## FAQ 20-01: Nine Mile Point Scram – Proposed NRC Response

Plant: Nine Mile Point Unit 1

Performance Indicator: Unplanned Scrams with Complications

### NMP1 Scram 9/6/17 Lo Reactor Water Level

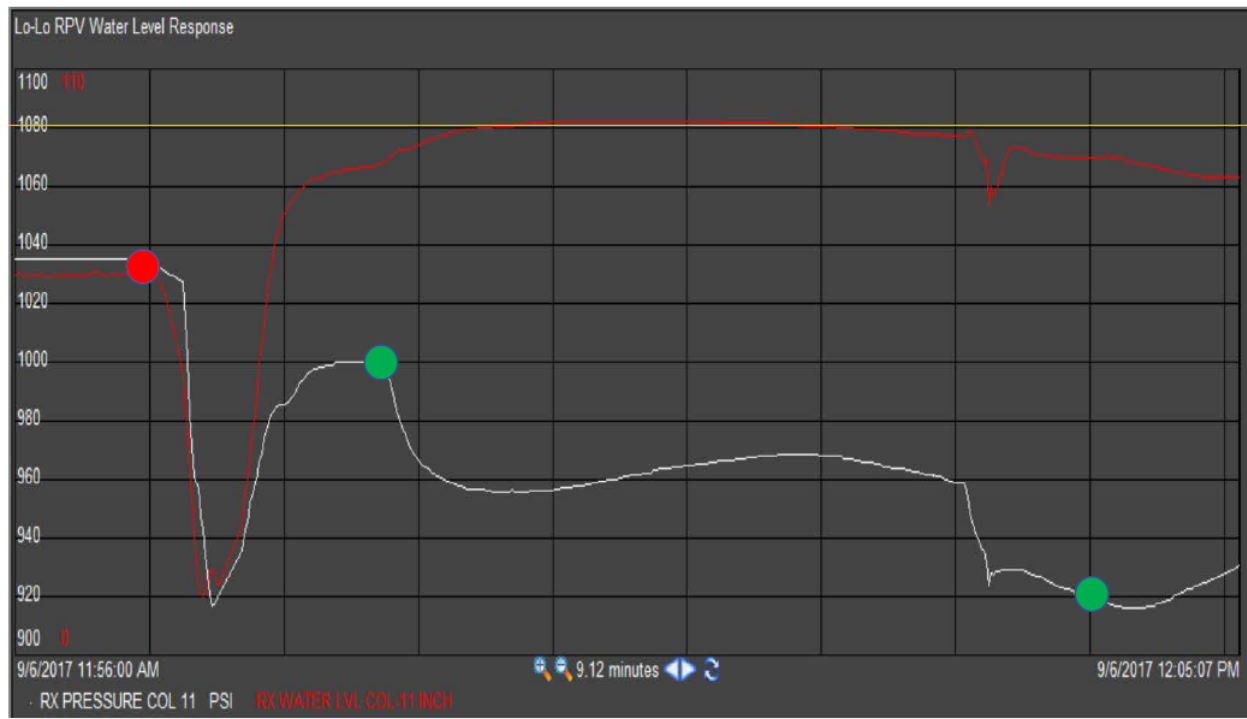
the scram response. As shown on Attachment 1, RPV Water Level and RPV Pressure responded as expected to the scram and no further equipment issues occurred during the scram response that cause complications required additional operator action to address. The entire transient spanned from the initiating event to the time the ECs were placed into operation.

The EOP entry condition associated with Lo RPV Water Level is expected and occurs as part of the normal plant response to a scram. Lo Lo RPV Water Level is not an entry condition in any EOP procedure. RPV Water Level was restored as expected using HPCI. Operators established pressure control in accordance with N1-EOP-2 by manually initiating EC 11 during the initial transient (as shown in Attachment 1) and maintained reactor pressure below any further EOP entry conditions. Pressure control was maintained using EC 11 and then TBVs following restoration of the MSIVs. Following the initial transient, reactor pressure and drywell pressures remained below EOP entry conditions. The highest RPV pressure following the transient was

1005 psig which is well below the entry condition of 1080 psig. No other EOP entry conditions were met during the scram response. Therefore, the answer to this statement is "No."
